Access Compliance Report

Public Rights-of-Way

(Curb Ramps)

Intersection ID: 49920	Main Street: AUSTIN_DEKOTA_DR	Cross Street: WANAMASSA_DR	Location:	N
ADA ID: 87D3FCE06B3A	Ramp Type: BlendTrans1	Initial Pass/Fail: Fail	Overall Compliance: No	Severity Score: 8.75
Codes/Mitigation Info/Possible Solution		Field Measurements/Component Compliance

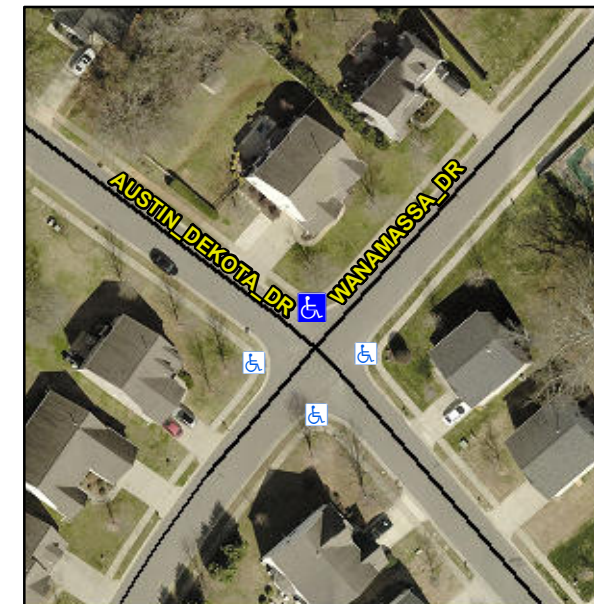
Not Found, R304.5.1

Remove & Replace Curb Ramp With Two New Directional Ramps or Equivalent.
